DRAGADOS CANADA

We acknowledge receipt of your email dated July 21, 2015 relating to CH009 Interface Issues.

CH0009 – CONSTRUCTION OF NORTH AND SOUTH DAMS

Request for Proposal

Figure 1: Spillway Bridge, Long-Sault Rapids, ON (Algonquin Bridge)

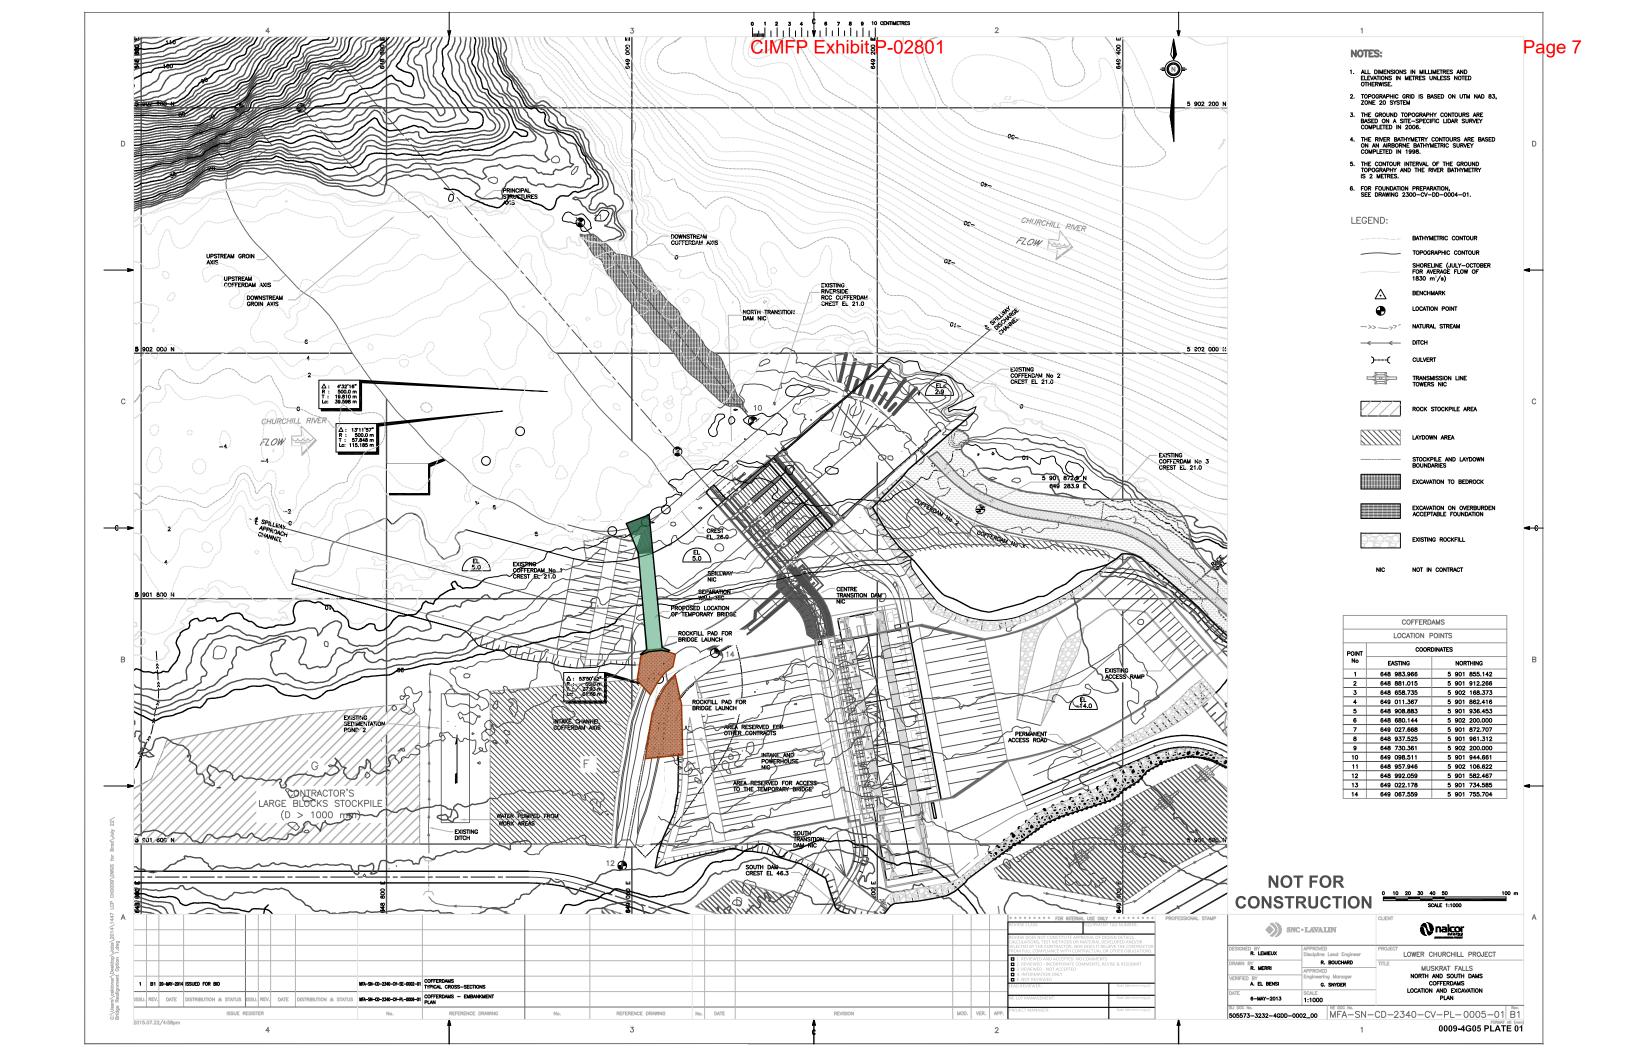
The need to give up access to the area immediately East of the Intake Cofferdam. Minor adjustments to the cofferdam layout may be possible to facilitate access to the upstream temporary bridge.

The temporary bridge across the spillway approach channel will consist of one 80m span and one 20m (+/-) span as illustrated on the attached drawing. We will realign the bridge to match up closer to the intake cofferdam. This will minimize any encroachment into the intake area as requested in your email to Mr. Leonard Knox dated July 21, 2015. We may require some fill on the inside of the cofferdam in order to create a straight launching area. This can be removed after the bridge is installed.

Originally the 20m span was going to be either a truss system or steel girder system, however we will now have to adjust the pier design to allow for a flared 20m section in order for the bridge to align properly with the starter groins. Therefore the 20m section will now consist of steel girders rather that a truss system.

The south abutment will be established in an area of competent rock with minimal overbreak. This may require some realignment of the bridge. It will consist of a concrete retaining wall structure on the edge of the spillway channel. The area between the south abutment and the transition dam will be filled with rock fill. The existing bank in-situ rock will be structurally secured with rock bolts.

An intermediate pier will be established on the north edge of the spillway channel. This will consist of structurally securing the existing rock with rock bolts. A concrete foundation will be poured. A steel pier will be designed and fabricated off site which will be bolted to the concrete. The steel pier now will be in a wedge shape to allow for the flare of the bridge. When the bridge is eventually removed, the steel pier will be unbolted and removed. The concrete abutments and retaining wall will be installed outside of the limits of the spillway approach channel and therefore will remain in place.

Annex A13-11

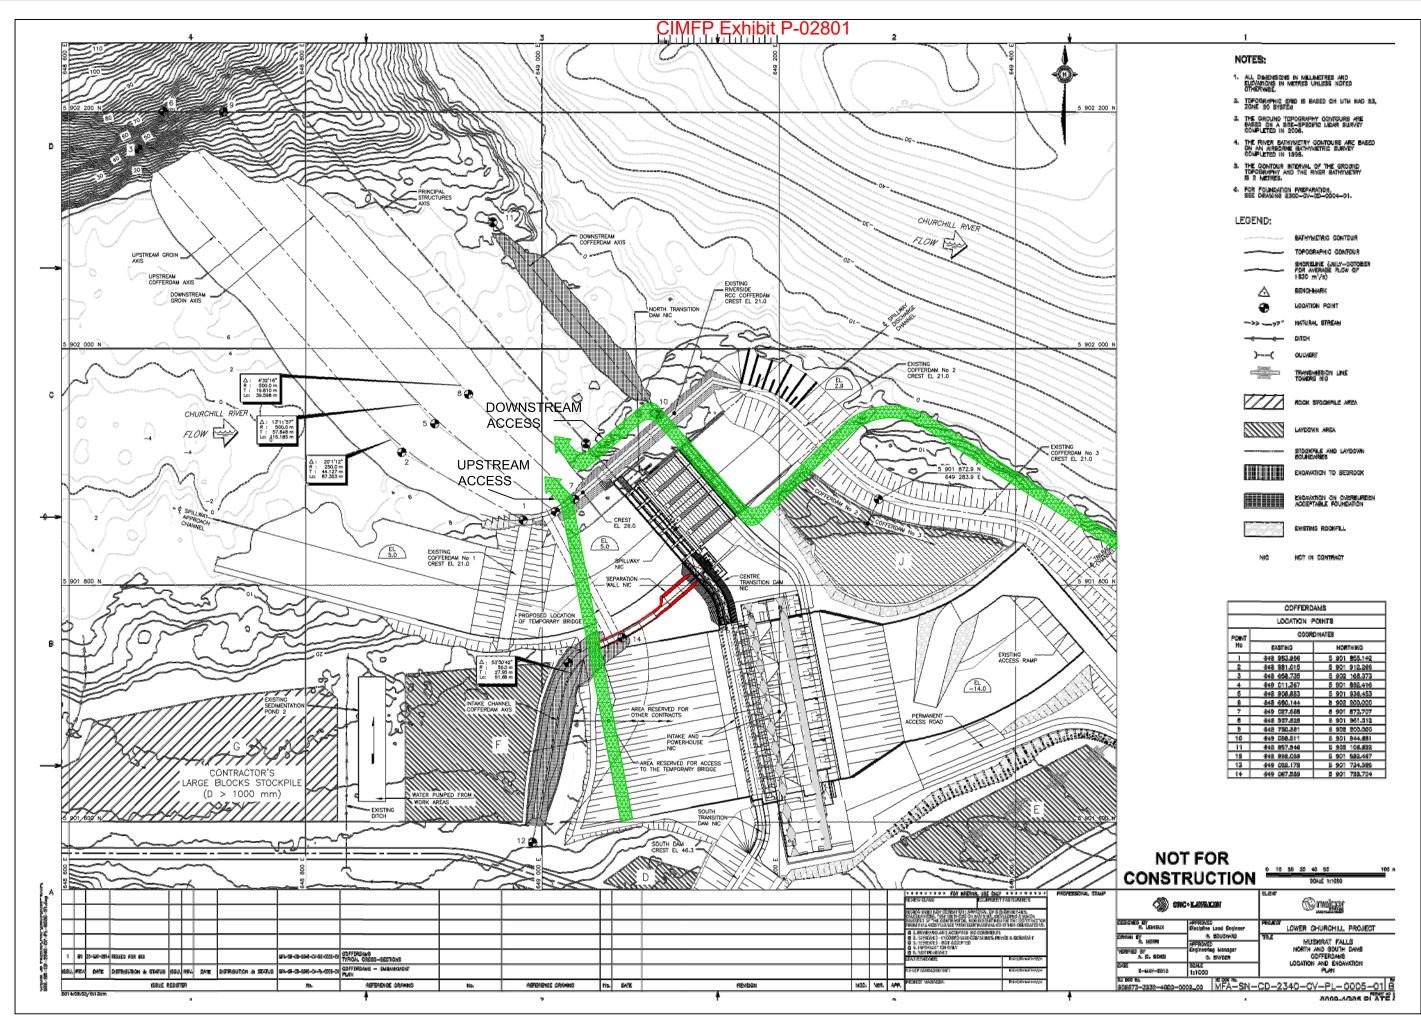
The need to share a portion of Laydown Area J, and to allow unobstructed access across Area J. A roadway of approximately 10 meters width must be shared with other project contractors. All maintenance of the roadway will be responsibility of Bidder.

The access to Area J will change once the existing cofferdams and rock section is removed. Please refer to Annex 13-4 and 13-11 drawings. A copy of each has been attached.
